**Document DCO 7.18**

# **Note on Changes to Public Right of Way and Works Nos.14 and 15**

**JUNE 2026**

# **The East Midlands Gateway Phase 2 and Highway Order 202X**

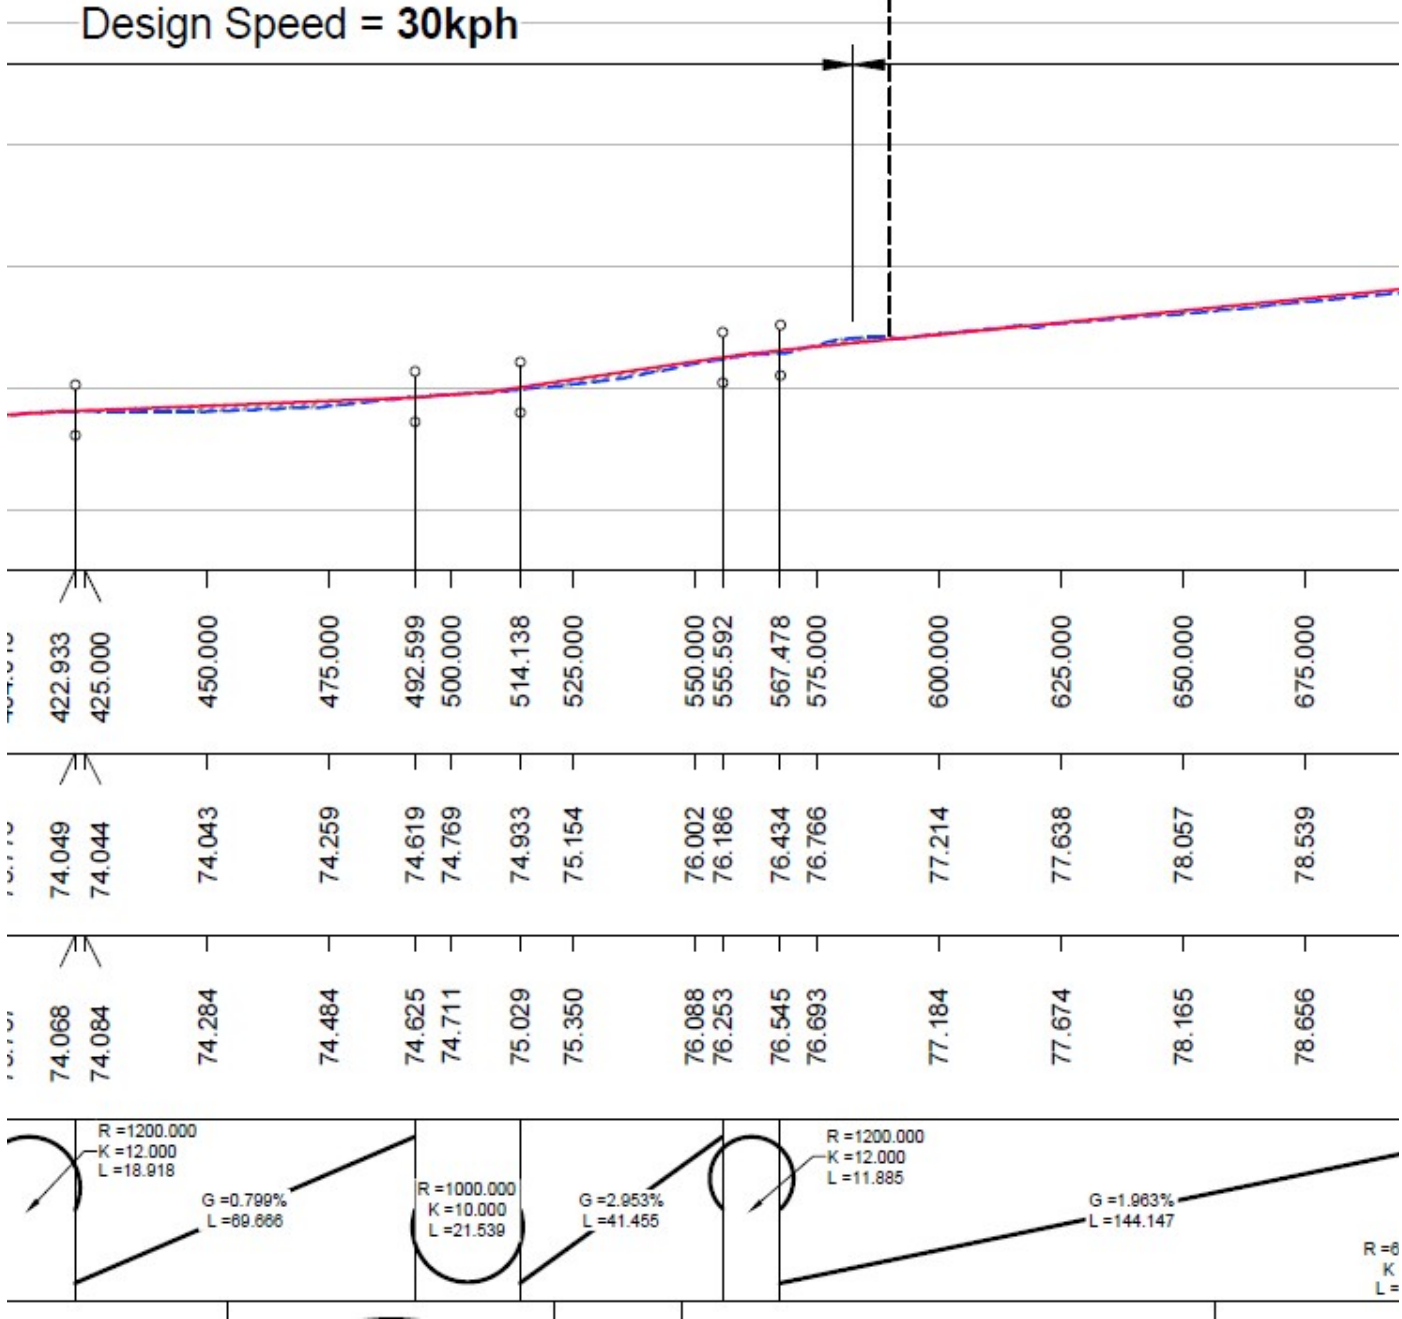
Many thanks for the email below. I can confirm that as per the longsection extract below the longfall does not exceed 3%.

**LCC WORKS**  
 LTN 1-20  
 Design Speed 30kph

**NH WORKS**  
 CD 195  
 Design Speed 30kph

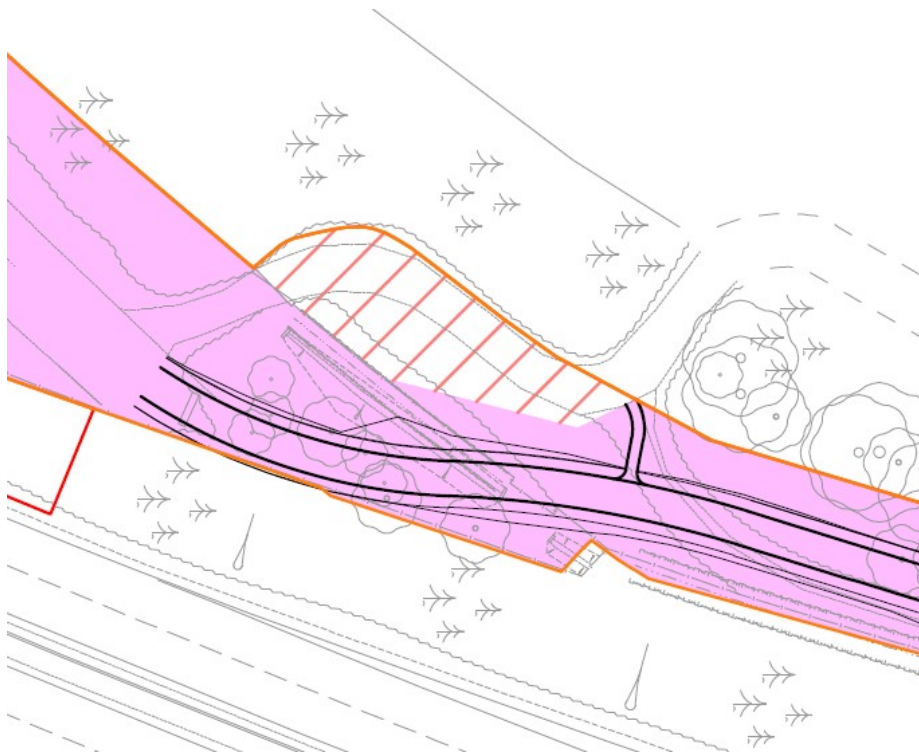
Further to our site walkover last week we have now, as promised, reviewed the alignment of the active travel link by the STW compound access.

As we discussed on site we have been able to realign the route to avoid the double bend in the STW compound access which retains their access in its current location. This is shown on the attached revised layout plans (apologies this area crosses the sheet boundary).

As for the other change we will need to obtain agreement from LCC on this before we can formally update our DCO drawings but before we do so please can you confirm this amendment is agreed in principle with yourselves? I've also attached a revised plan showing the area that can be removed from the CA (snip below).

Thanks for the revised drawings as discussed. In principle I can confirm agreement to the revised route. I am just questioning whether the entire access for STW could be removed from the CA? I appreciate it would make the line a little odd but thinking to avoid multiple parties needing to maintain that access.

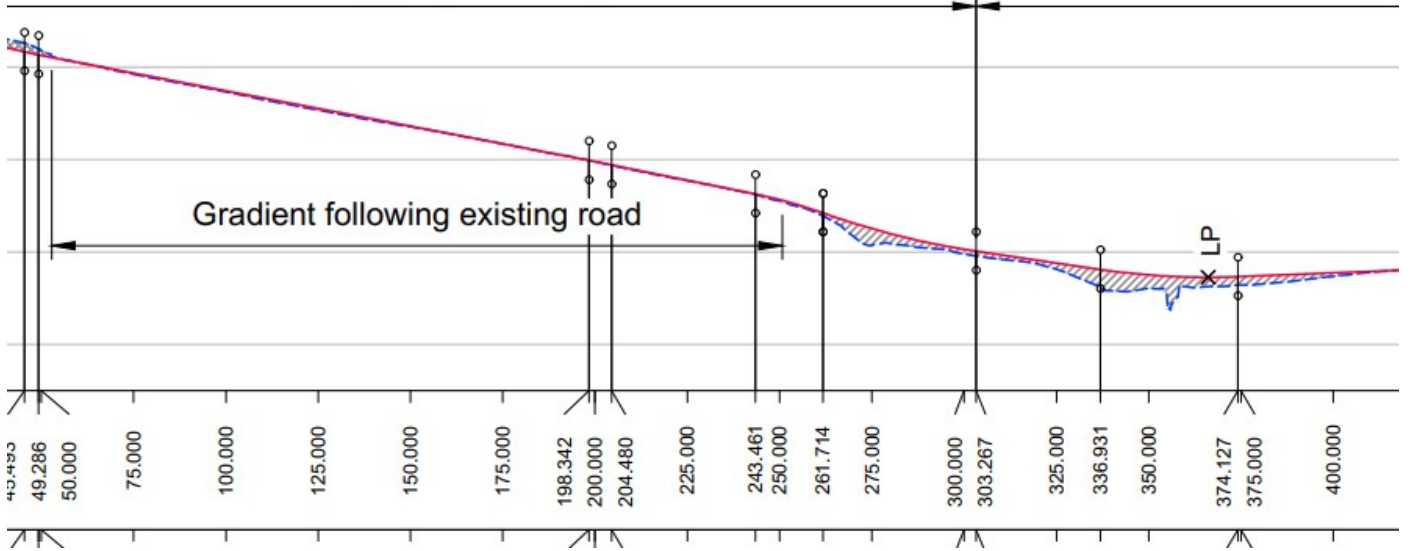
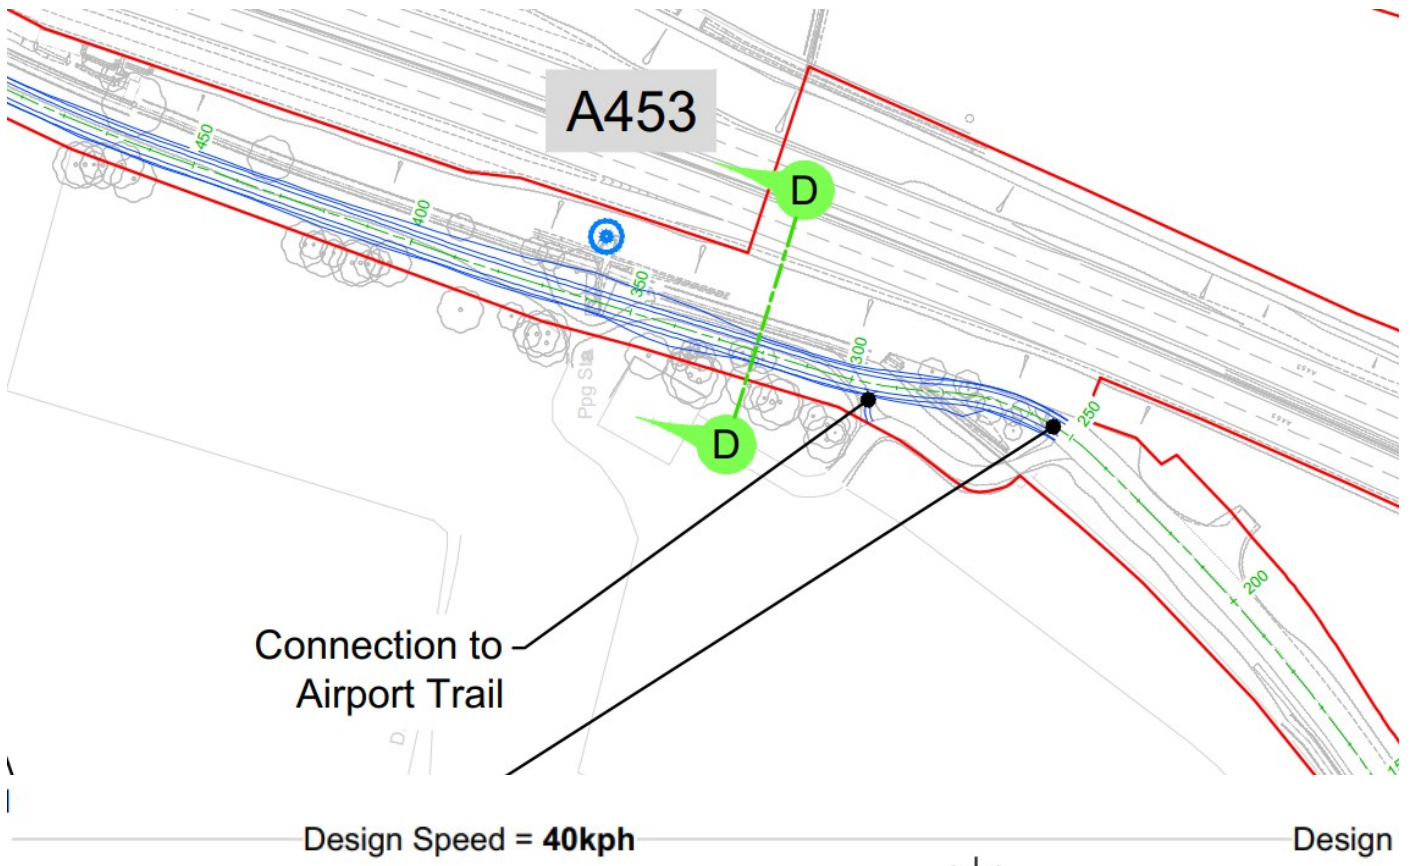
As I noted at our meeting on 8<sup>th</sup> May we have had ongoing discussions with EMA on the active travel link (ATL). Following a site walkover with them in addition to the change already discussed around the car park area they asked if we can avoid affecting the access into the Severn Trent Water compound. We have achieved this by a very minor amendment to the horizontal and vertical alignments of the ATL and the extent of change is shown on plan and longsection on the snips below.

The updated technical drawings are attached and I should be grateful if you would confirm agreement to this change as we are proposing to submit this change at Deadline 4 (along with the previously agreed change).
